Docket No. 50-354

SUBJECT: HOPE CREEK INDEPENDENT DESIGN VERIFICATION PROGRAM (IDVP)  
OBSERVATION REPORTS

LSP-29

As Shown on Drawing

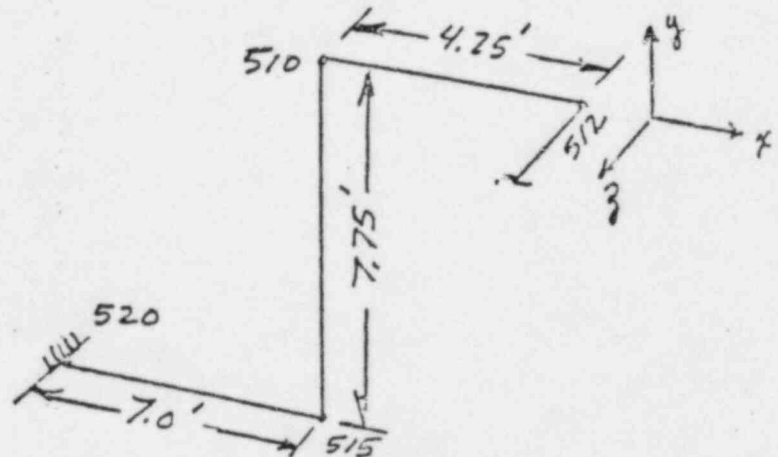
1. Structure(s), system(s), or component(s) involved:  
Calculation No. C-1750-3Q, dated 2/13/84, Safety Auxiliary Cooling System Piping.
2. Description of Observation:  
In calculation C-1750-3Q, the computer model of line 155-HBC-30, from node 512 through node 520 does not appear to agree with the routing shown on drawing HG-1-P-EG-13, Revision 10D, dated 2/1/84.  
(continued on next page)

In the computer analysis, the line is modeled as a span of 4.25 feet from node 510 north to node 512 (X direction), followed by a span of 7.75 feet downward to node 515, followed by a seven foot span north to the anchor at node 520.

Drawing HG-1-P-EG-13 shows a downward span of twelve feet from nodes 510 to 515, followed by a span of seven feet north to the anchor at data point 520 with no 4.25 foot span in the X direction from node 510.

4. Recommendation for resolution (optional):
  - a. Provide justification that the discrepancy in the computer model has been reconciled with the design drawing.

- b. Provide assurance that other piping stress analyses have been reconciled with the design drawings.
5. Internal Review Committee classification of Observation:  
         Not significant to safety (See Item 6)  
         Additional information required (See Item 6)  
         Potentially Significant to Safety (See Item 8)
